Proposal of amendment to ECE/TRANS/WP.29/GRSP/2014/2 and ECE/TRANS/WP.29/GRSP/2014/5 (Proposal by European Commission of amendment to Phase 1 and draft Phase 2 to global technical regulation No. 9 Pedestrian Safety)

Example of marking of HIC1000 zone and HIC1700 zone

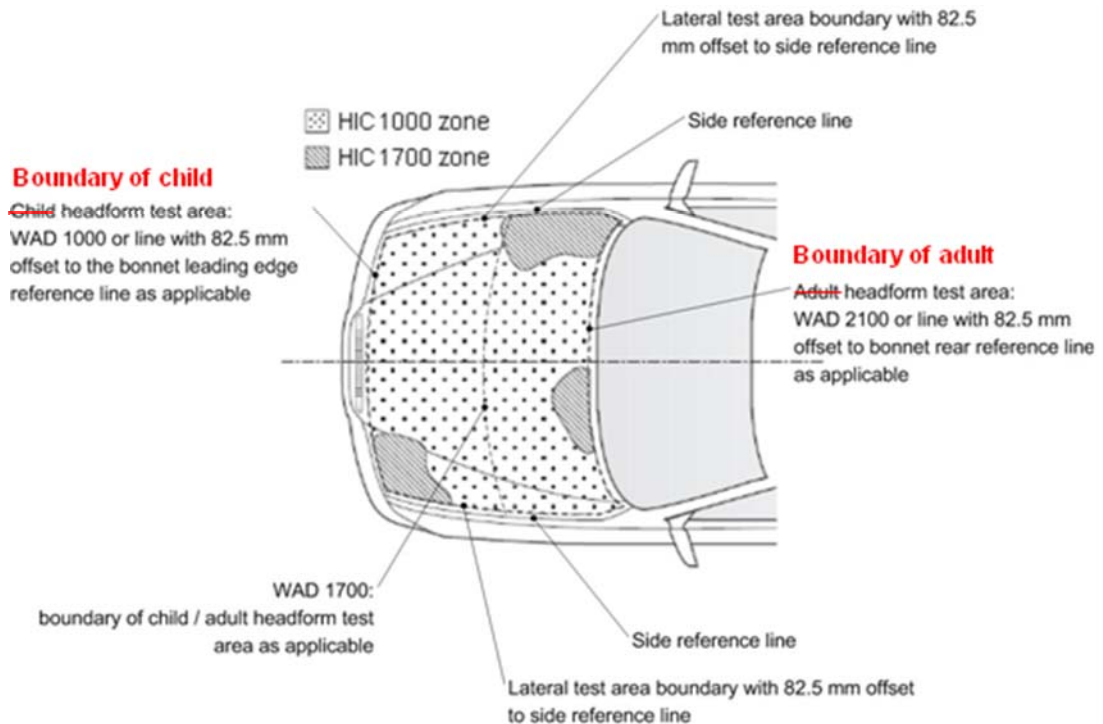
Figure 11 Example of marking of HIC 1000 zone and HIC 1700 zone, replace the Republic of Korea proposal as follow:

Aim of this proposal is to correct description of the figure with consistency as above.
